**ALLSTAR TECHNICAL NOTE**

**Product:** Challenger S (AC9300) and Challenger GL (AC9500)

**Subject:** Operator Does Not Run Using Radio Control

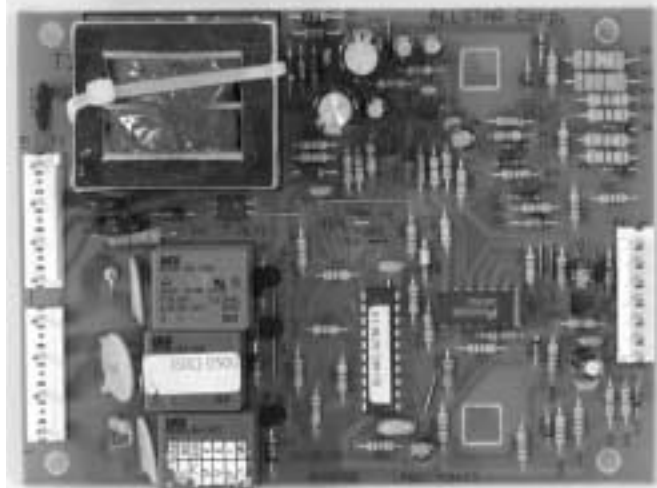
We have had some reports from customers that sometime after installation, the Challenger Operator stops working from the radio controls however continues to work properly from the wall button. Only a small number of operators have exhibited this problem. A picture of the subject control board is below.

Field returns and lab testing indicated that a component on the control board was being damaged. Under certain conditions, electrical noise from thunder storms, electrical appliances and other inductive loads could enter the control circuit, by way of the pushbutton wires, and damage electrical components on the control board. Further testing showed this problem could be virtually eliminated by upgrading a component on the control board. When tested in the lab, the control board with the new component withstood 3 times more voltage than the control board using the old component.

All products, including finished operators, replacement boards and warranty repairs, produced after June 27<sup>th</sup> will have the upgraded component installed in the control board.
